Product Change Notification

Change Notification #:	110161 - 00
Change Title:	Intel PRO/1000 PT Dual Port Server Adapters, EXPI9402PT/PTBLK/PTG2P20/PTG2L20, MM#868973/868971/882028/882886 (Redwater Retail/OEM generic) and PRO/1000 PT Quad Port LP Server Adapters, EXPI9404PTL/PTLBLK, MM#884309/884311 (Kirkwood LP Retail) PCN 110161-00 Label OUI Block change, 3n1 label change
Date of Publication:	August 09, 2010

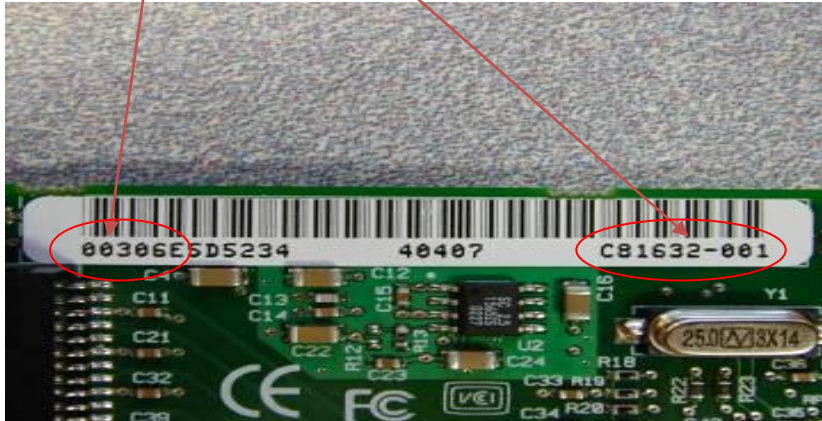
OUI Block change: Past run rates have caused the available blocks of MAC addresses assigned to run out. The OUI Block 00-15-17 has hit the low water mark, the new OUI Block will be 00-1B-21.

3n1 label change: The 3n1 label will change to reflect the new OUI Block number and PBA# dash roll (printed board assembly), as show in the picture below. The 3n1 label is placed on the Front side of the Printed Board. (picture example only)
